Figure 4. High capacity well effects on groundwater.
Source: Michigan State University Extension, Water Quality Bulletin # 35, August 1991.

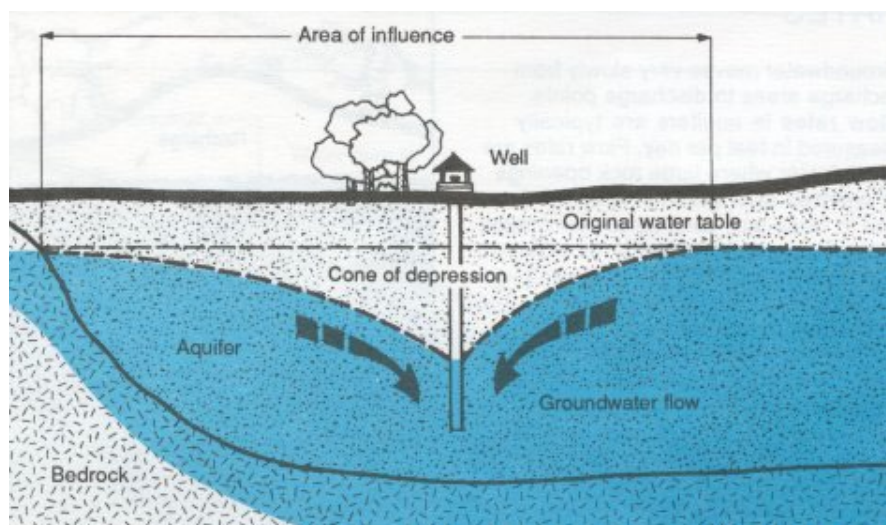
As mining activities proceed (excavation and hydraulic mineral extraction) groundwater will be drawn in contributing to a growing body of surface water. Impacts on local water table elevations and groundwater flow direction will be similar to the effects from a high capacity well (Figure 4), in concept, not necessarily in magnitude. An argument could be made that a high capacity well is an inaccurate analogy due to the mine operating as a closed loop system, where extracted groundwater will be returned to the surrounding aquifer post-processing, causing no changes to local groundwater elevations or flow paths. This is debatable due to:

- 1) Evapotranspiration from the lake surface
- 2) Water losses during processing
- 3) Unknowns related to:
 - a. Rate of groundwater recharge from processed wastewater
 - b. Rate of groundwater extraction from hydraulic dredging and lateral effect
 - c. Connectivity with groundwater flow paths near the pumping zone of influence

Figure 5. Hydric soils, depressions, internally drained areas and drainage patterns within the proposed mine site.
Source: Dane County DCiMap Version 5.6.

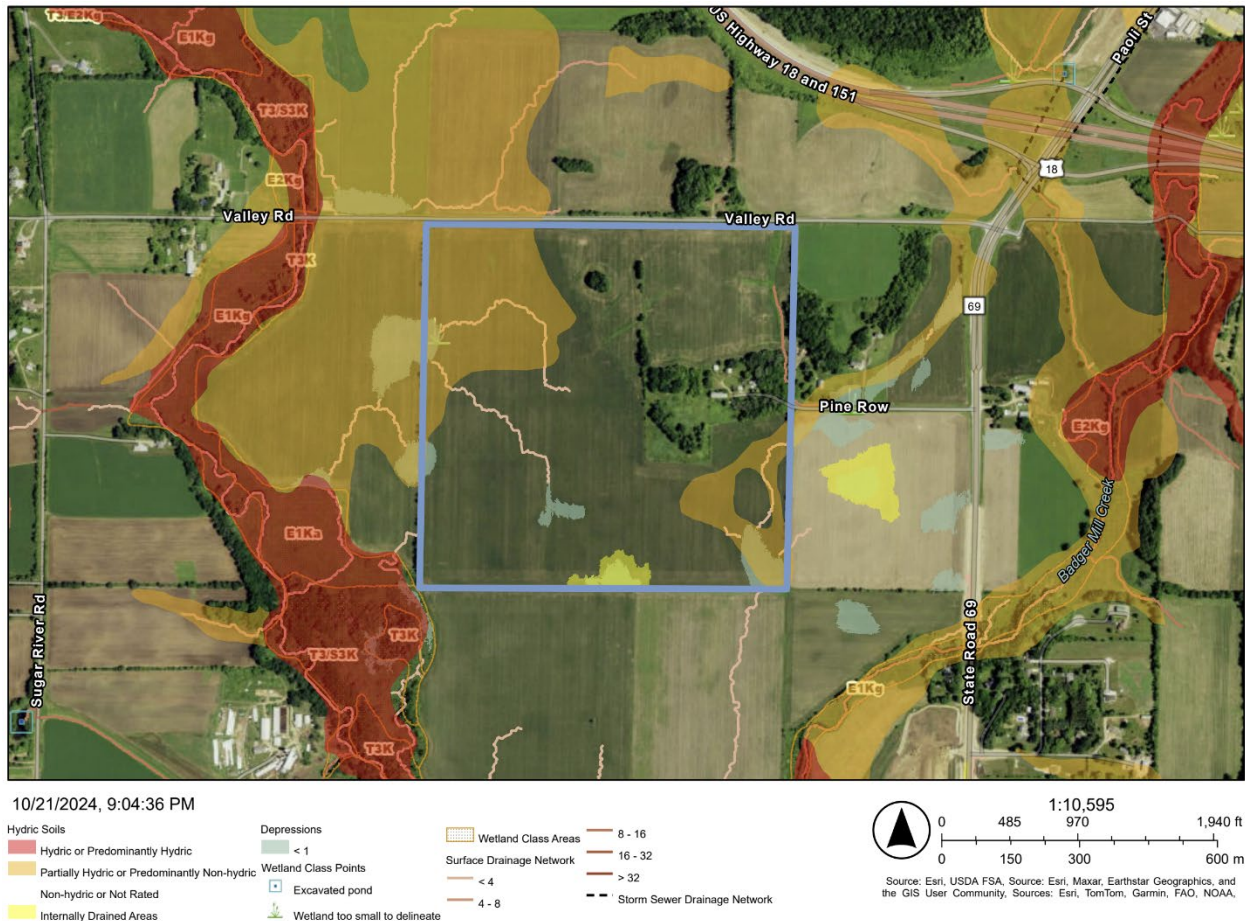
The Applicant states there are no wetlands on the property, but there are multiple depressions and approximately 32.5 acres of mapped hydric soils within the 160 acres associated with the CUP application (Figure 5). Wetlands should be delineated to determine if adequate protection and buffering can be accomplished in administering Dane County Ordinances Chapter 11 and 14, relating to stormwater management and shoreland-inland wetland regulations.
